Technical Service Bulletin (TSB)

A/C Blowing Warm Air

REFERENCE:	TSB: 08-122-25 REV. A GROUP: 08 - Electrical	Date:	April 23, 2025	REVISION:	08-122-25
VEHICLES AFFECTED:	2022 - 2024 (WL) Jeep Grand Cherokee/Grand Cherokee L This bulletin applies to vehicles equipped with the 2.0L I4 DOHC DI Turbo PHEV Engine (Sales Code ECX).			MARKET APPLICABILITY: ☒ NA☐ MEA ☐ SA☐ IAP ☐ EE☐ CH	
CUSTOMER SYMPTOM:	Customers must experience a Malfunction Indicator Lamp (MIL) illumination and the vehicle must set the following Diagnostic Trouble Code (DTC): - B3A11 - A/C Refrigerant Expansion Valve Actuator Control Circuit Performance. Customer may also comment on the following: - A/C system blowing warm air.				
CAUSE:	Supplier quality spill

Fig. 1
Chiller With Green Check Mark And Part Number Location

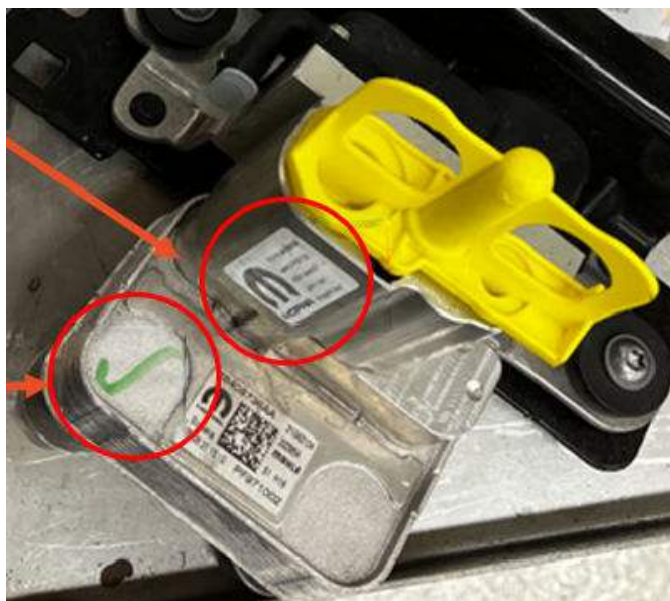
1. Open the hood and check the chiller for part numbers 68470822AA or 68470822AB, then look for any green check marks [Fig. 1](#).
2. Are there part numbers 68470822AA or 68470822AB and any green check marks on the chiller [Fig. 1](#)?
 - YES >>> Proceed to [Step 3](#).
 - NO >>> This bulletin does not apply. This bulletin does not apply.

3. Replace the battery chiller. Refer to the detailed service procedures listed in DealerCONNECT>Service Library>Service Info under: 12 - Electrified Powertrain System / Battery Cooling / Chiller / Removal and Installation.
4. **For model years 2022 and 2023 only**, install wire harness jumper 68510660AA.
5. Clear any DTCs.
6. Fast charge the vehicle and drive for 16 km (10 mi) and confirm DTC is cleared.
